Hydrol. Earth Syst. Sci. Discuss., author comment AC3
<https://doi.org/10.5194/hess-2022-215-AC3>, 2022
© Author(s) 2022. This work is distributed under
the Creative Commons Attribution 4.0 License.

Reply on RC3

Author comment on "Application of an improved distributed hydrological model based on the soil–gravel structure in the Niyang River basin, Qinghai–Tibet Plateau" by Pengxiang Wang et al., Hydrol. Earth Syst. Sci. Discuss.,
<https://doi.org/10.5194/hess-2022-215-AC3>, 2022

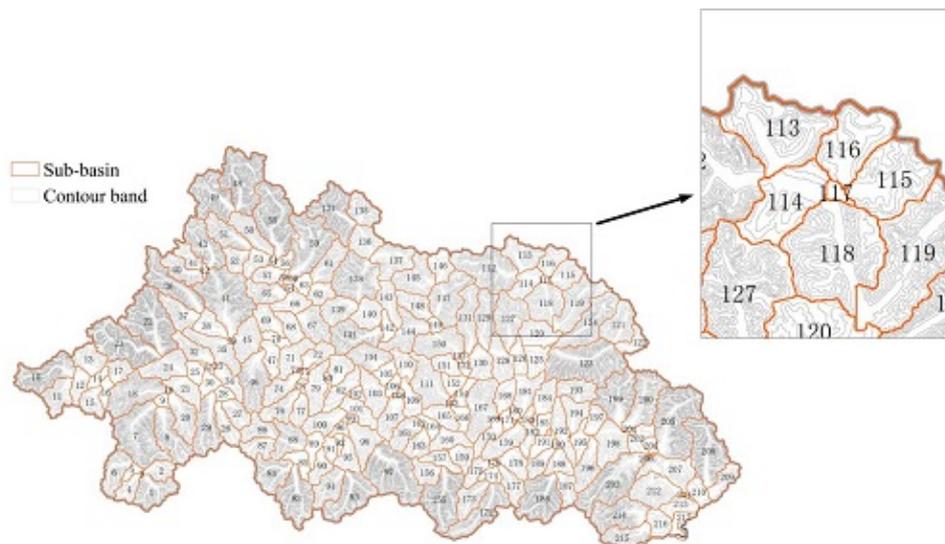
"The large portion of gravel in the gravel layer causes the formation of macropores, which are connected to form a fast channel for transporting water during heavy rains"

I am totally confused here. As I said earlier, it is indeed the general way gravel formations are treated (as a conductive layer). But before the authors wrote :

"However, since gravel can neither conduct nor store water, the gravel [...] hinders the movement of water and affects the water retention curves"

So how does all of this work together? The authors have been, since the beginning, using studies on soils containing rock fragments to support a certain type of behavior from their bottom layer and now they argue towards another behavior because they have been calling these fragments "gravels". And at this stage I am confused. Maybe I missed something here but if so, there is a lack of pedagogy/clarity in the way this model and stratigraphy works together.

Reply: Sorry for the unclearness on this part. There are macropores in the soil-gravel mixture (SGM) layer. In a saturated state, the macropores form a fast channel for transporting water. However, when the SGM layer is in an unsaturated state, the water mainly moves under the actions of the matrix potential and gravitational potential. Thus, in an unsaturated state, the macropores do not work, and the gravel will hinder the movement of water. In the revised version, we explain this in detail.

Figure 3c: Snow–soil–gravel layered structure.

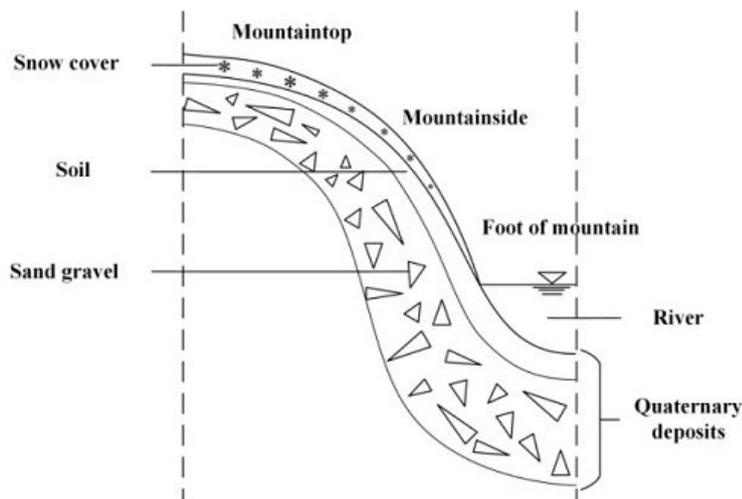
"In the non-freeze-thaw period, the calculation object of water movement was defined as the dualistic soil-gravel structure (Fig. 3a). The upper layer is soil whose thickness and number of layers are determined by the location of the calculation unit; the thickness of the soil layer gradually decreases from the foot to the peak of the mountain. The lower layer is the gravel layer (mixed layer of soil and gravel)."

This is really hard to read/understand, rephrase, with examples and tangible elements.

Reply: We rewrote this sentence and illustrated it with Figure 3c:

"In the non-freeze-thaw period, the calculation object of water movement was defined as the dualistic soil-gravel structure. The upper layer was soil, whose thickness was determined by the location of the calculation unit and which gradually decreased from the foot to the peak of the mountain (Fig. 3c). The lower layer was the gravel layer (mixed layer of soil and gravel)."
